## City of Hanahan

TO: All Prospective Offerors  
FROM: Procurement  
RFQ #: COH# 372024  
RFQ TITLE: Electronic Security System

### ADDENDUM NUMBER 2 – 6 PAGES

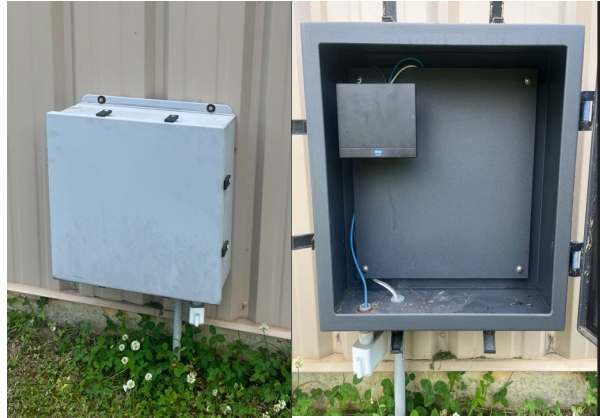
19. Is there any way you can tell us where the controller is to the gate keypad at public works?  
Possibly even send us a picture.

The control is located on the back left side of the building close to the fuel pumps. (pictures attached)
